Access Compliance Report Public Rights-of-Way (Curb Ramps)

Intersection ID: 21061 Main Street: SARDIS_RD Cross Street: SMITHFIELD_DR Location: NE

ADA ID: B95695FBE944 Ramp Type: PerpDiag Initial Pass/Fail: Fail Overall Compliance: No Severity Score: 37.5

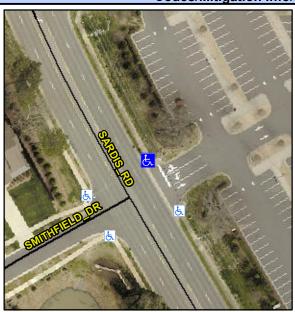
Not Found, R304.2.2, R304.5.3

| | | Data | Compliance Description | | Data |
|-----|-----------------------|-------|------------------------|-----------------------------|-------|
| N/A | Ramp Length (in) | 61.0 | No | Ramp Slope (%) | 8.6 |
| Yes | Ramp Width (in) | 54.0 | No | Ramp XSlope (%) | 8.4 |

Remove & Replace Curb Ramp With Two New Directional Ramps or Equivalent.
